Response to Information Request – Material Change of Use (Multiple dwelling and Short-term accommodation) – 8 Davidson Street, Port Douglas– Lot 704 on PTD2092

Date: 19 April 2024
Our Ref 47256RFI (1)
Development Application MCUC2024_5568/1 (Doc ID 1208441)
Approval Sought Development Permit
Property Address 8 Davidson Street Port Douglas
Property Description Lot 704 PTD 2092
Application Proposal Material Change of Use for Multiple Dwelling and Short-term Accommodation
Contact: Jenny Elphinstone

RESPONSE TO INFORMATION REQUEST ITEMS 1, 2, 3, 4 & 5

UNIT 3
SCALE - 1:200

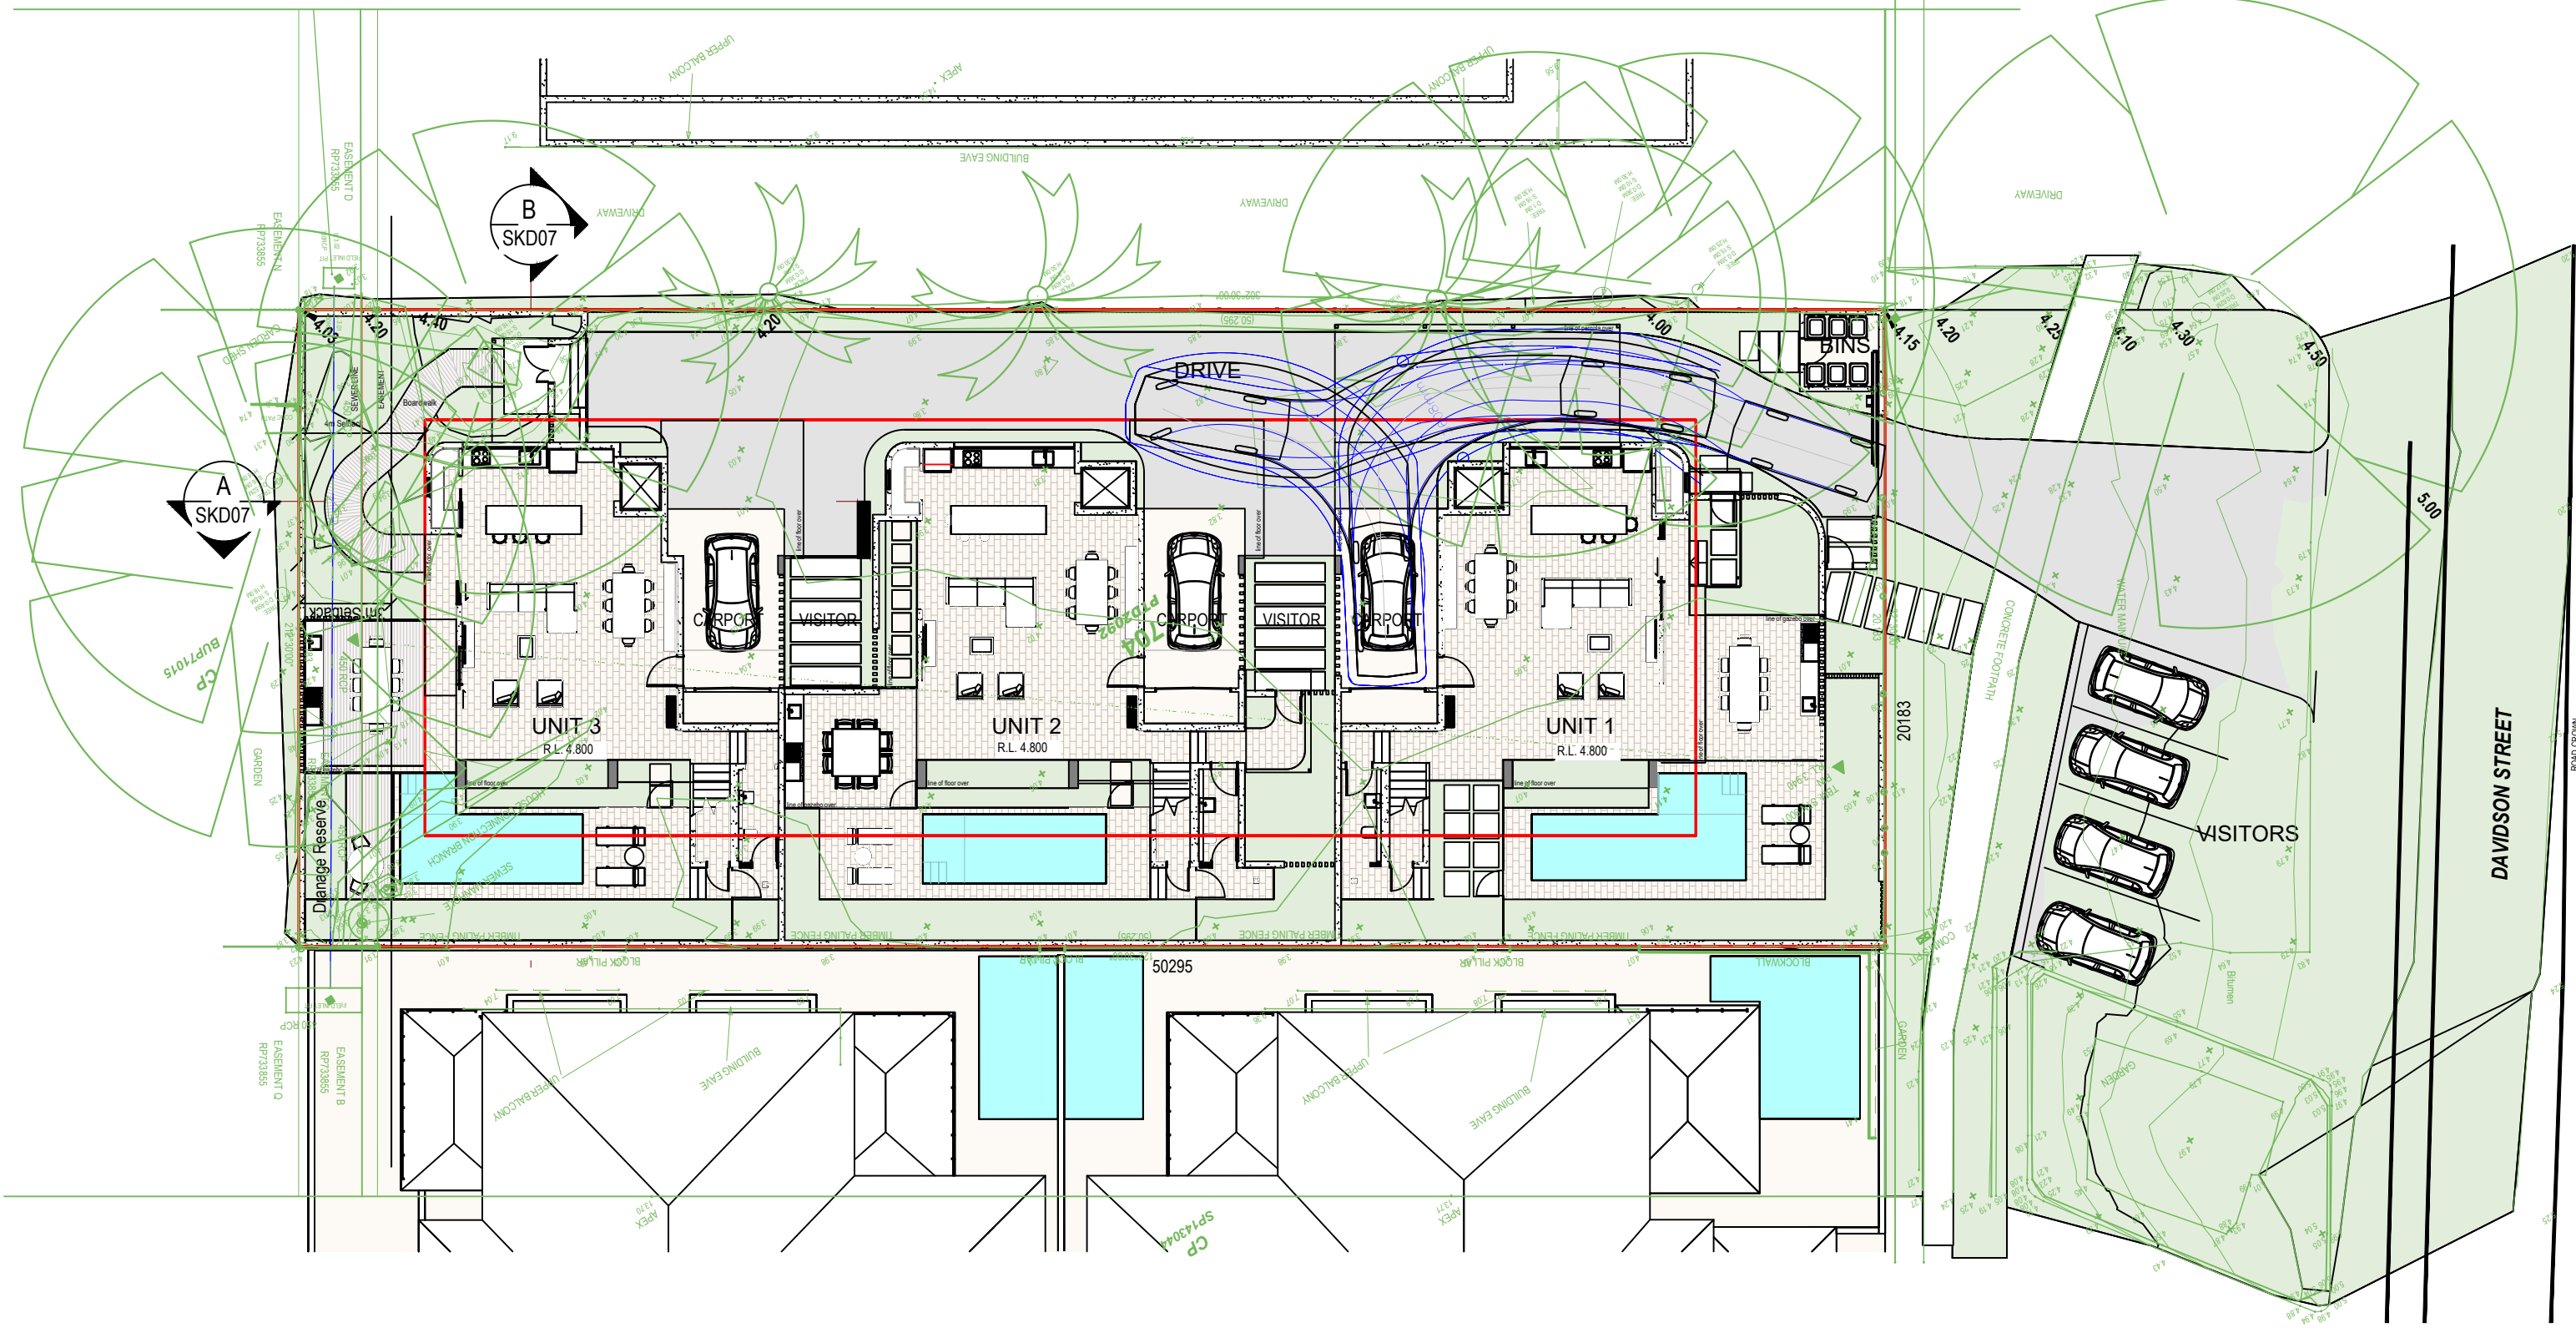
Please provide swept path turn details for proposed on-street parking spaces. Concern is raised with the rear turning interfering with the bicycle lane.

The swept path diagrams in Attachment A also show vehicular access to the internal car parks and garages. The access to internal carparks is serviceable and conforms with Australia Standard Codes.

Attachment B - Contributing Catchment Plan

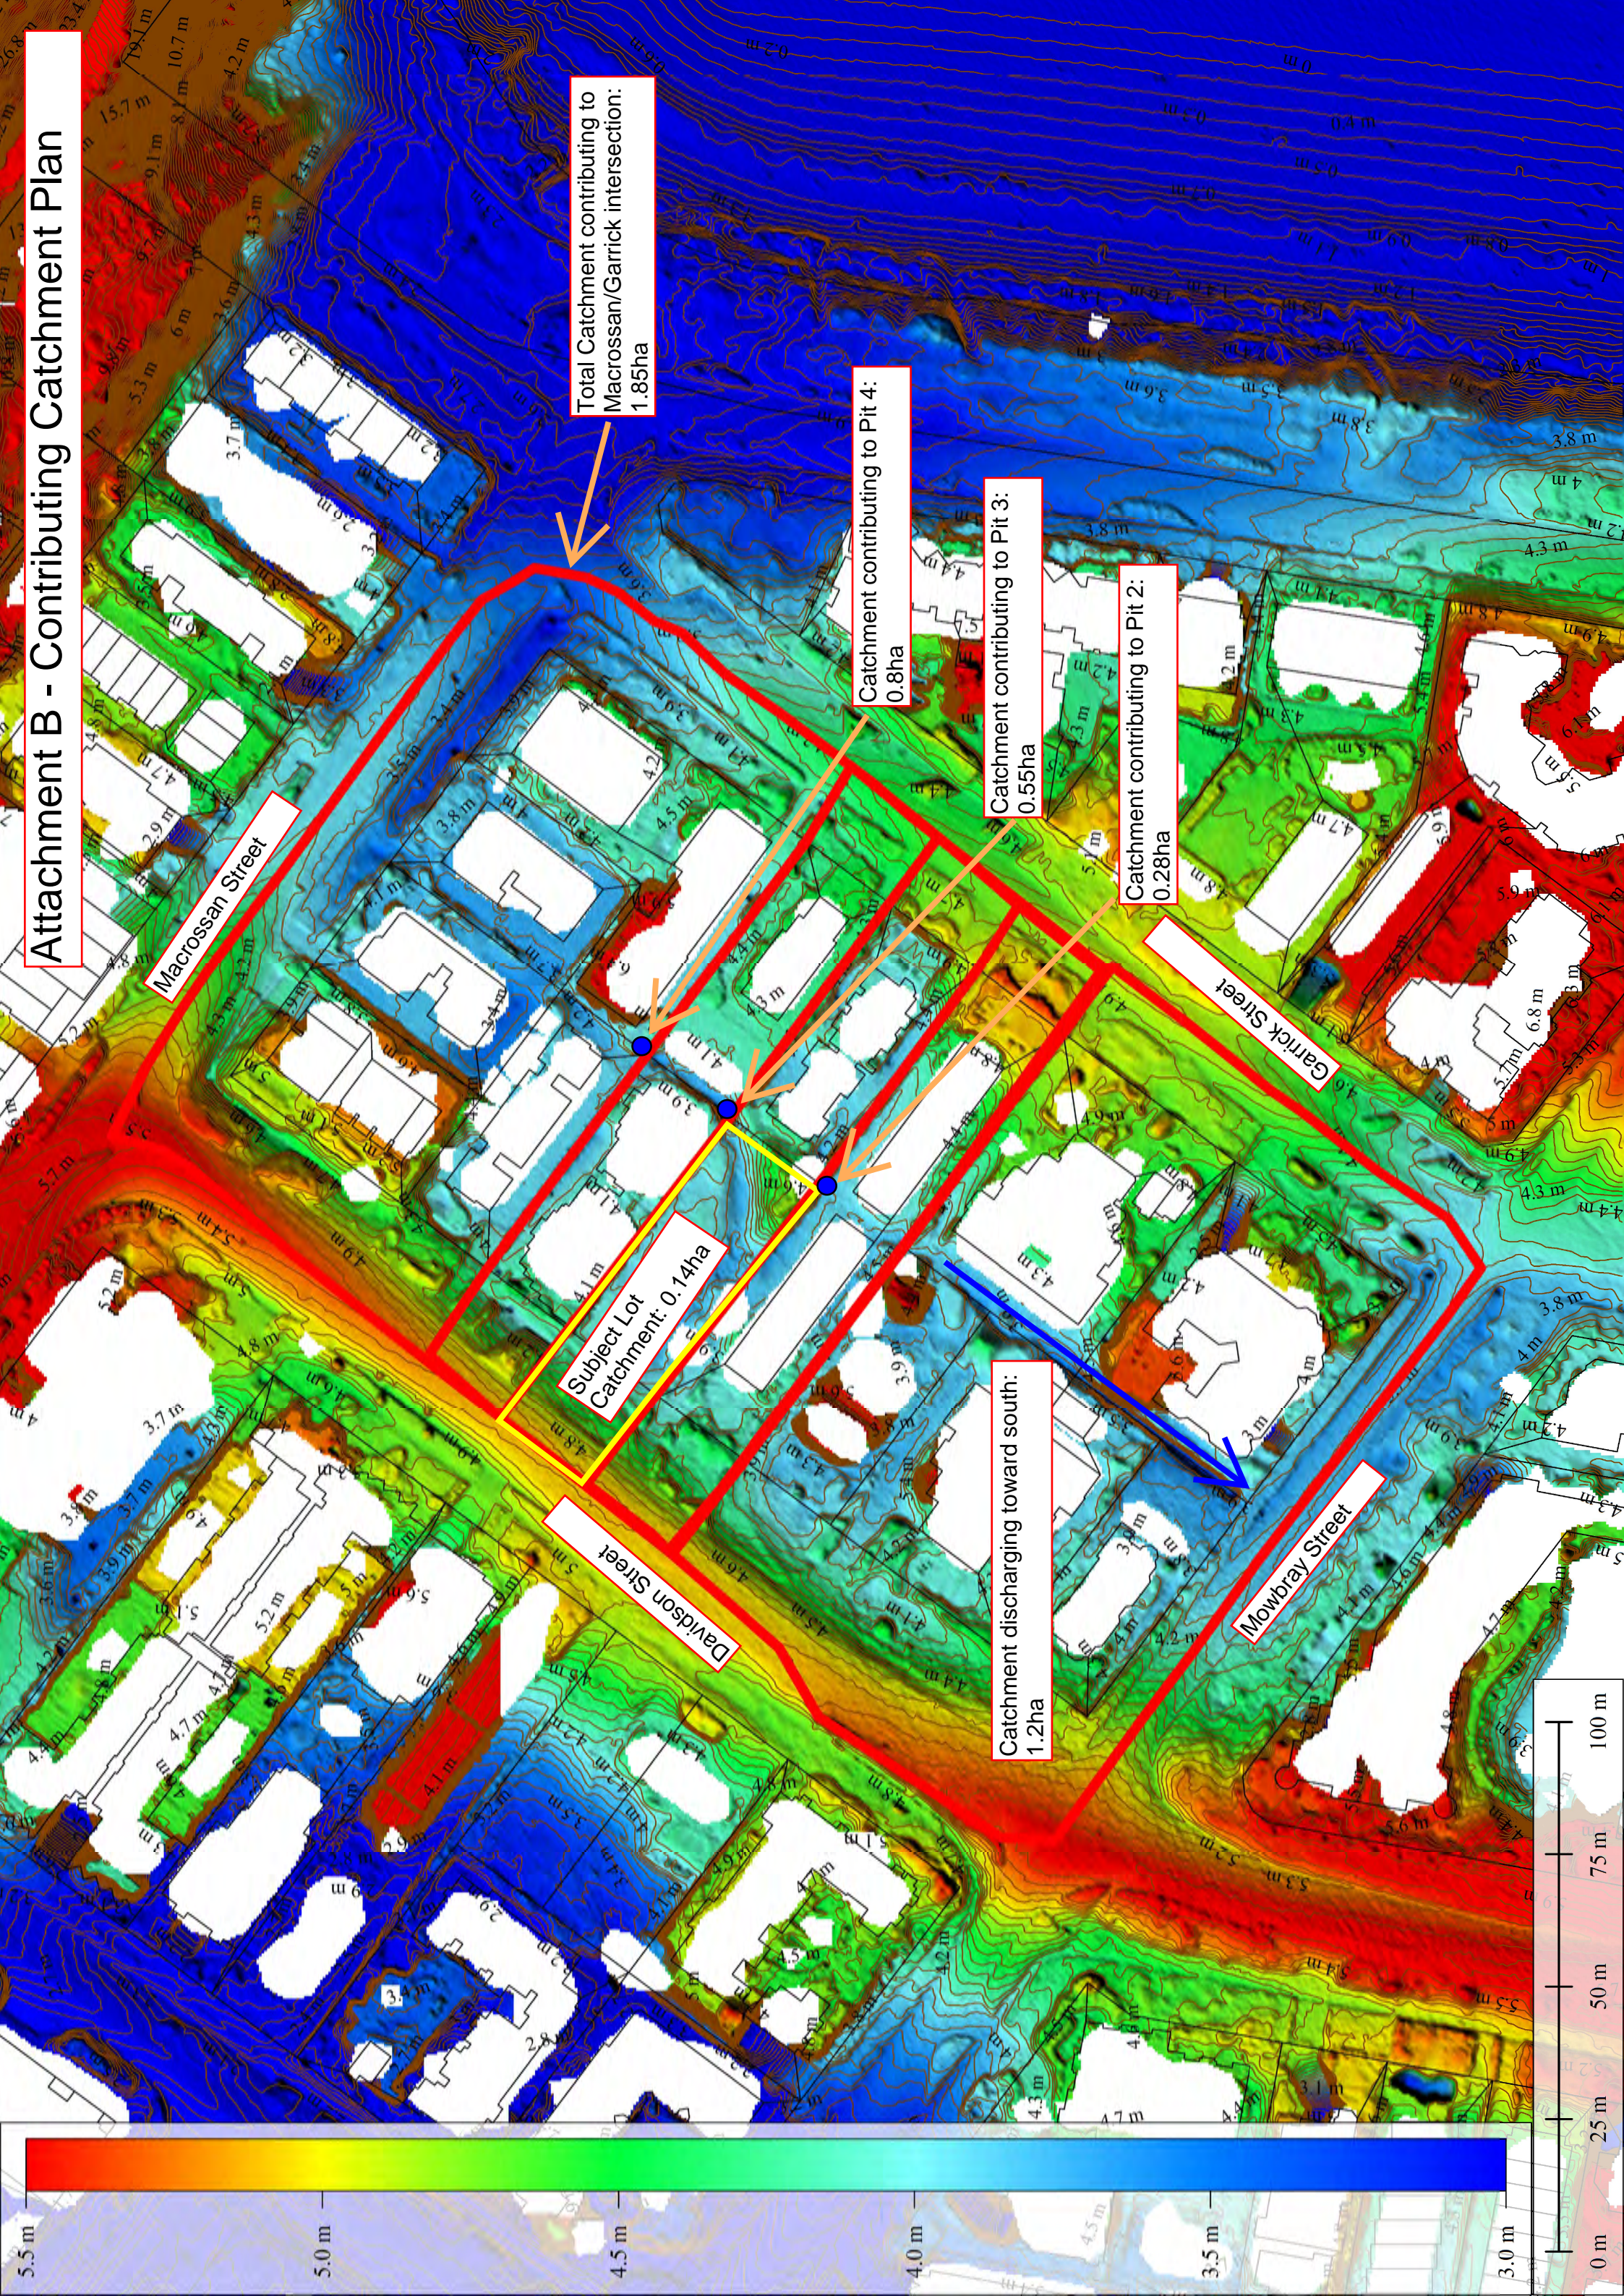
a. **The contributing catchment boundaries:**

The Catchment Plan (Attachment B) demonstrates the contributing catchment boundaries, including sub-catchments contributing to Pit 2 to 4.
